The Commission has issued the enclosed Amendments No. 20, 20, and 17 for Licenses No. DPR-38, DPR-47, and DPR-55, for the Oconee Nuclear Station, Units 1, 2, and 3. These amendments consist of changes to the Technical Specifications and are in response to your request dated December 1, 1975, as supplemented February 24 and 27, 1976.

OCONEE NUCLEAR STATION, UNIT 1

AMENDMENT TO FACILITY OPERATING LICENSE

Amendment No. 20
License No. DPR-38

UNIT 1
OPERATIONAL POWER IMBALANCE
ENVELOPE FOR OPERATION FROM
0 TO 230 ± 5 EFPD
OCONEE NUCLEAR STATION
FIGURE 3.5.2-3A1

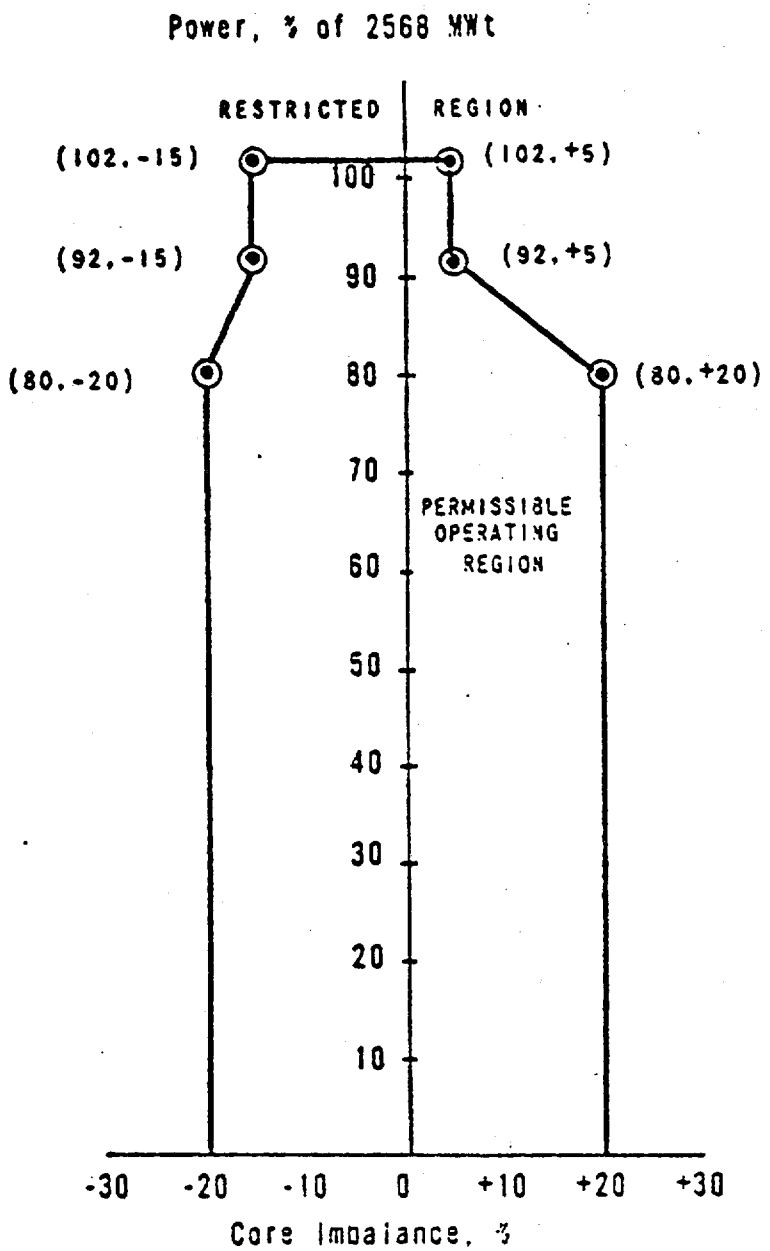
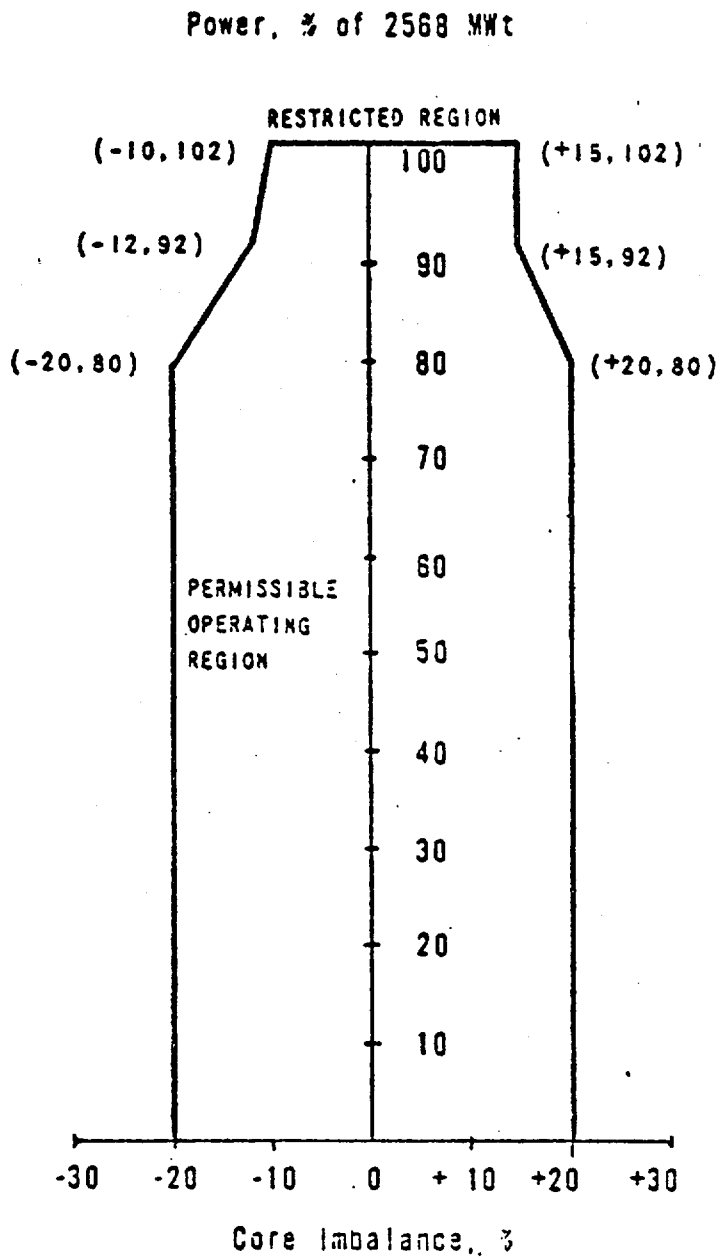
3.5.2.6 Reactor power imbalance shall be monitored on a frequency not to exceed two hours during power operation above 40 percent rated power. Except for physics tests, imbalance shall be maintained within the envelope defined by Figures 3.5.2-3A1, 3.5.2-3A2, 3.5.2-3B, and 3.5.2-3C. If the imbalance is not within the envelope defined by Figure 3.5.2-3A1, 3.5.2-3A2, 3.5.2-3B, and 3.5.2-3C, corrective measures shall be taken to achieve an acceptable imbalance. If an acceptable imbalance is not achieved within two hours, reactor power shall be reduced until imbalance limits are met.

The power-imbalance envelope defined in Figures 3.5.2-3A1, 3.5.2-3A2, 3.5.2-3B, and 3.5.2-3C is based on LOCA analyses which have defined the maximum linear heat rate (see Figure 3.5.2-4) such that the maximum clad temperature will not exceed the Final Acceptance Criteria. Corrective measures will be taken immediately should the indicated quadrant tilt, rod position, or imbalance be outside their specified boundary. Operation in a situation that would cause the Final Acceptance Criteria to be approached should a LOCA occur is highly improbable because all of the power distribution parameters (quadrant tilt, rod position, and imbalance) must be at their limits while simultaneously all other engineering and uncertainty factors are also at their limits.** Conservatism is introduced by application of:
